PRODUCT CHANGE NOTICE

PCN#19-050**NOTIFICATION DATE: April 26, 2019****MODEL(S) AFFECTED:**

Temporary change to substrate material and appearance based on supplier lot variation

Bottom View
(Picture - 2)

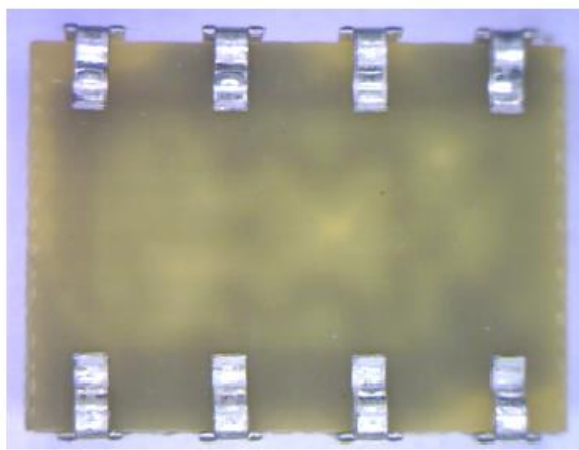
- No change to FIT (dimensions) or FUNCTION (performance)
- Change to FORM (appearance)
- Elimination of green solder mask on the bottom of the device for some lots.
- No change to datasheet specifications
